Mitigation Plan

Mushroom Meadow Mitigation Site

Caswell County, North Carolina
Roanoke River Basin HUC 03010104
DMS Project ID No. 100192
Full Delivery Contract No. 200204-01
USACE Action ID No. SAW-2021-00348
NCDWR No. 20210400, V1

Subject: Mitigation Plan
Mushroom Meadow Mitigation Project, Caswell County
Roanoke River Basin HUC 03010104
USACE Action ID SAW-2021-00348/NCDWR 20210400, V1

01/11/2023
DATE
39077.34
PROJECT NO.
S-04
SHEET

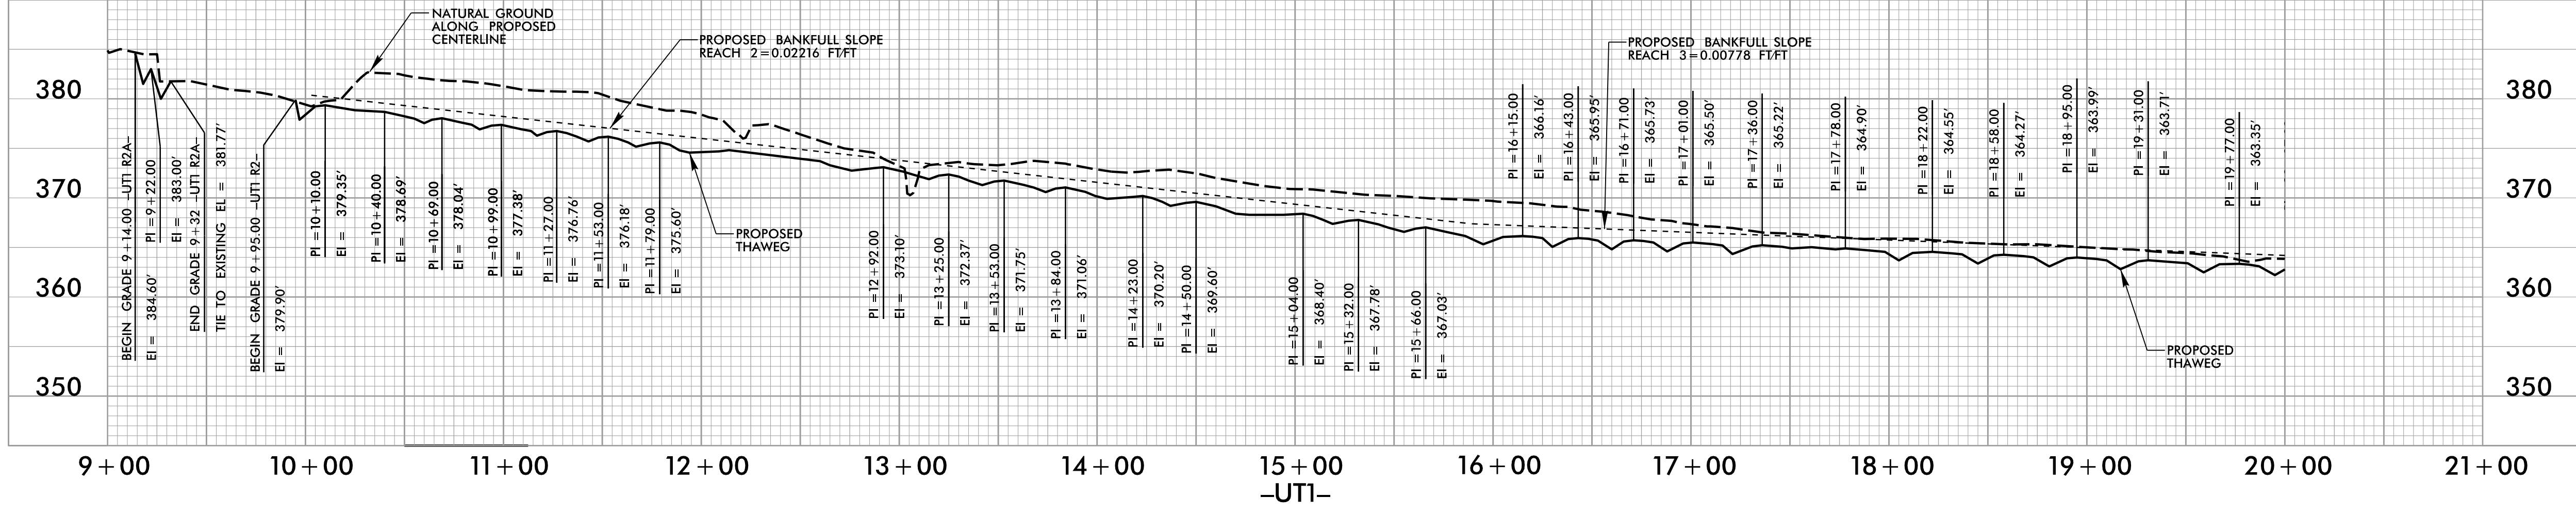
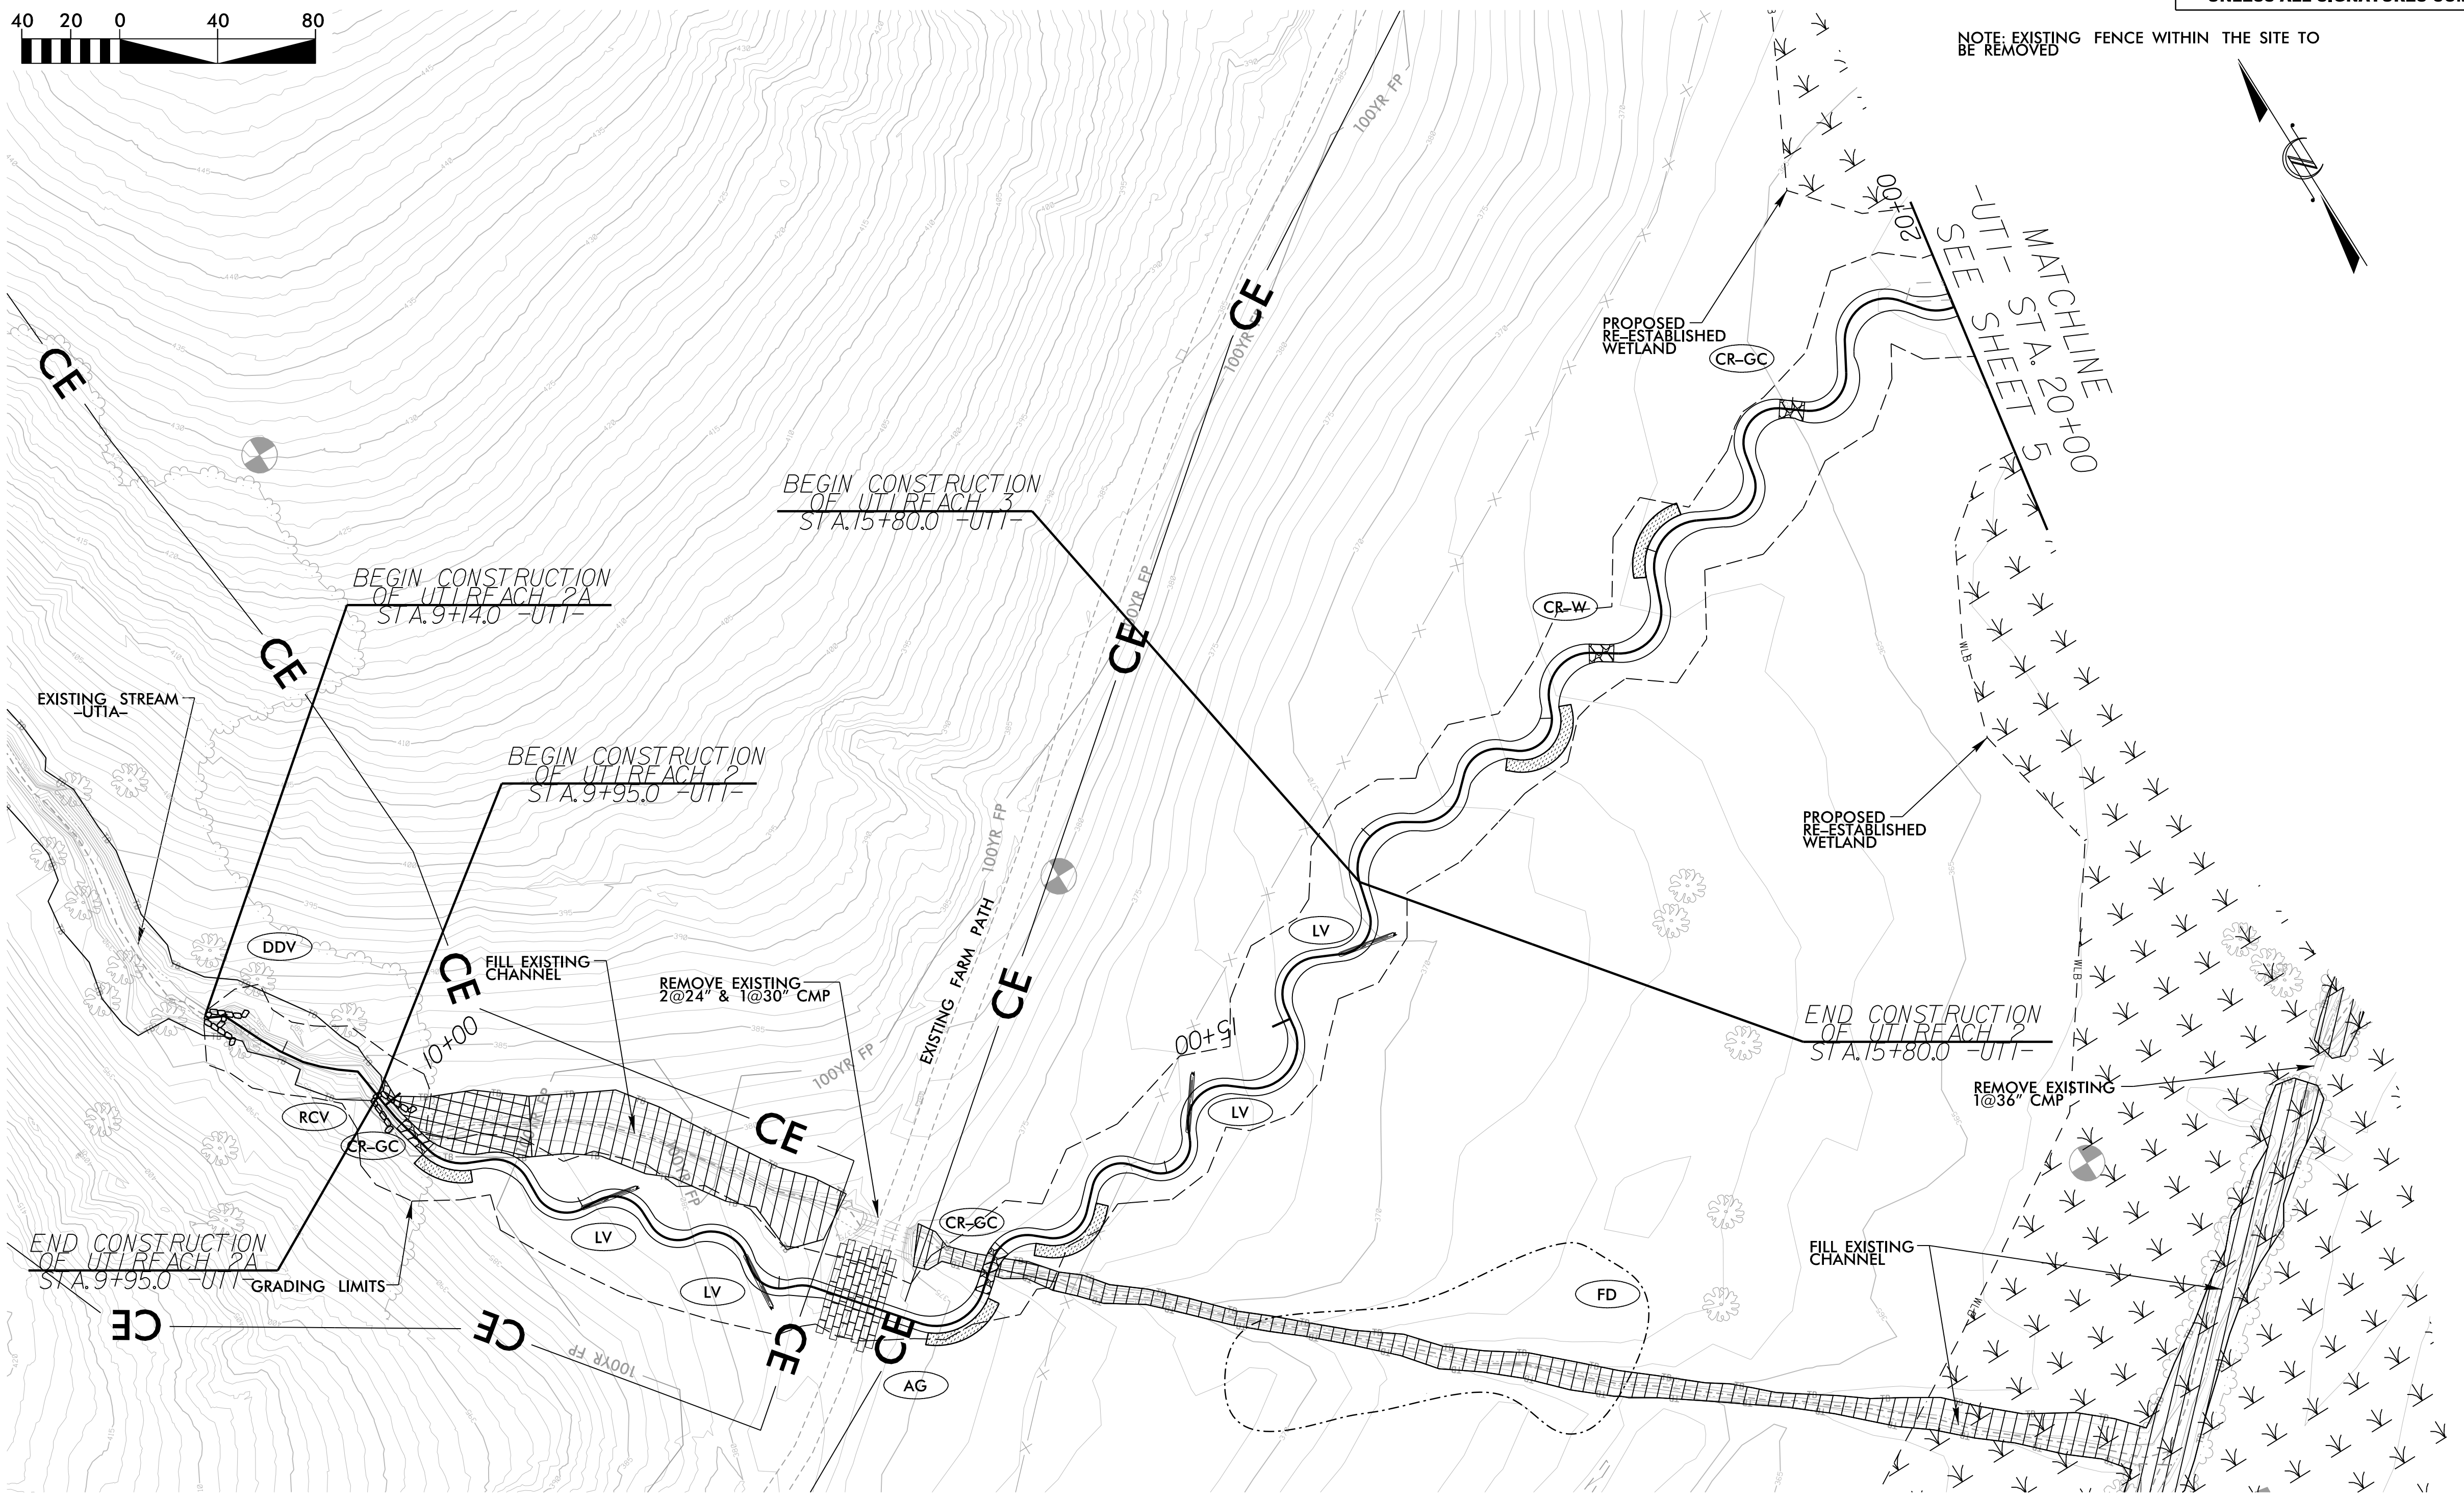
30. Sheet S-04 – Please add a callout to existing stream UT1A. Also, please callout existing fence within the site to be removed. **A callout has been added to existing Stream UT1A. A note has been added on S-04 and S-05 to remove existing fence within the project site.**

31. Sheets S-04 & S-05 – Please confirm that no riffles are proposed UT2 Reach 2 and only three riffles total are proposed along UT1 Reach 2 and Reach 3. Are there add concerns about long- term stream bed stability and/or bedform diversity enhancement? (Side note, it would be helpful to have more station labels along reaches.) **Additional riffles have been added to UT1 R3 and UT2 R2. Begin and end construction labels have been added.**

EC-02.5
SHEET

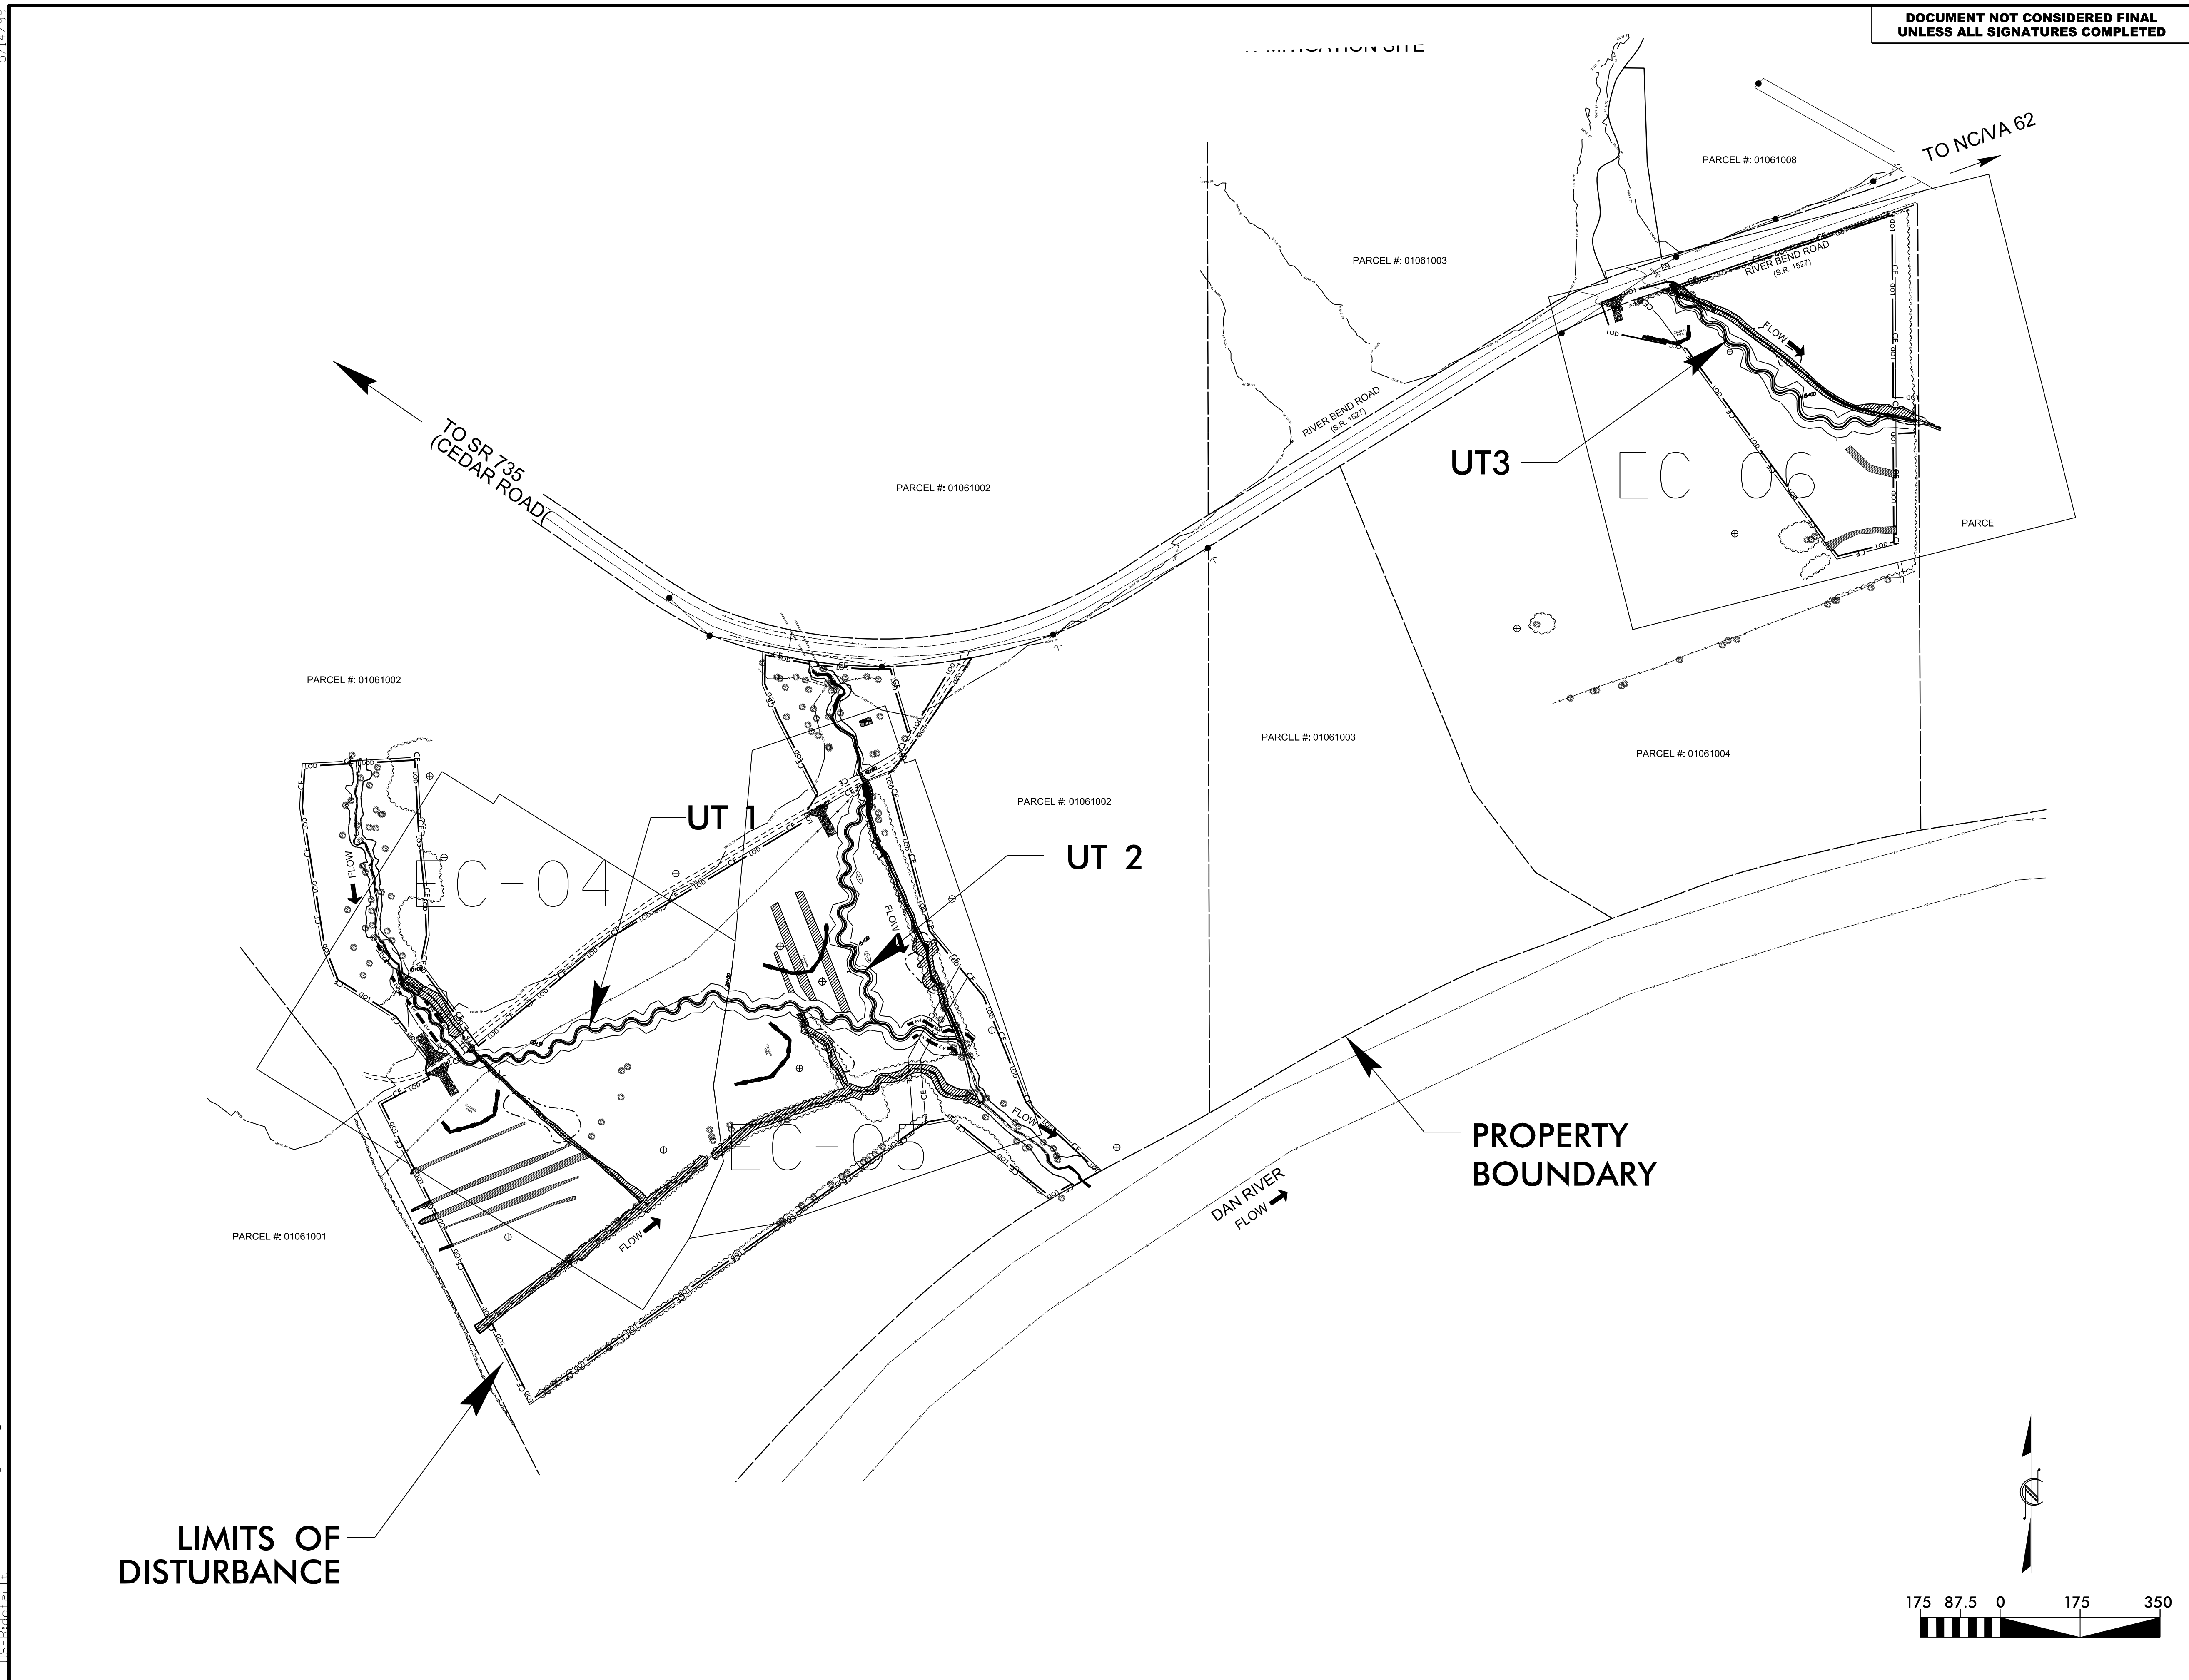
1. Sheet EC-02.5 (pg. 147) – The Temporary and Permanent Seed Mix table is very hard to read, especially the temporary mix. I think the temporary mix is the same as Sheet PLT-01 (pg. 135) so I am fine with the species. **The plan sheet has been updated for clarity.**
2. I would like to see one or more flowering herbaceous species in the upland, wetland, and riparian mixes (such as Eupatorium spp., Solidago spp, Rhexia spp., Monardia spp.). **We have added *Helianthus angustifolis* to the seed mix.**
